19 SUB2007-00325

ALOYIS PARK SUBDIVISION RESUBDIVISION OF LOTS 24 & 25

DETAIL SITE PLAN

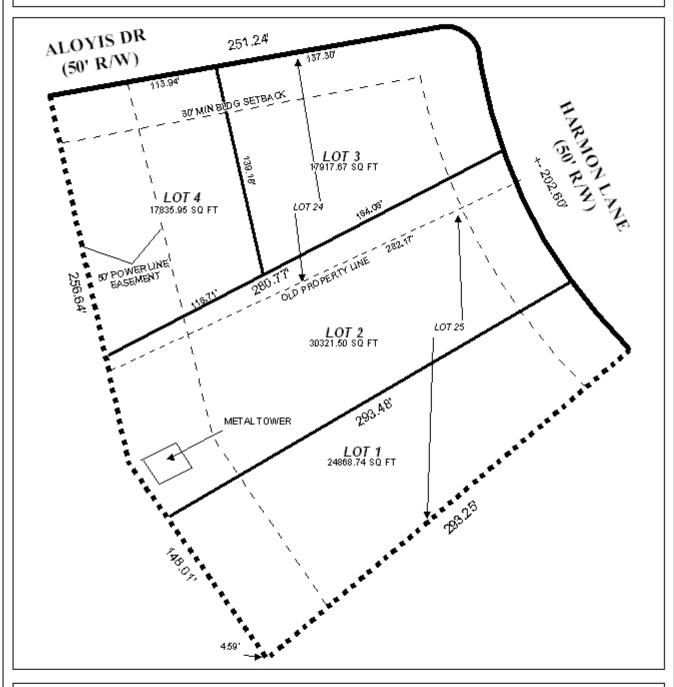
The subdivision consists of four proposed lots with adequate frontage on public streets. A note should be placed on the final plat stating that each lot is limited to one curb cut, with the size, location, and design to be approved by County Engineering and conform to AASHTO standards.

As illustrated on the plat, there is a 50' utility easement on the Western portion of the site. A note should be placed on the final plat stating that no construction will be allowed within the utility easement.

- 1) placement of a note on the final plat stating that each lot is limited to one curb cut, with the size, location, and design to be approved by County Engineering and conform to AASHTO standards;

- 2) placement of a note on the final plat stating that no construction will be allowed within the 50' utility easement;
- 3) the applicant receive the approval of all applicable federal, state, and local environmental agencies prior to the issuance of any permits;
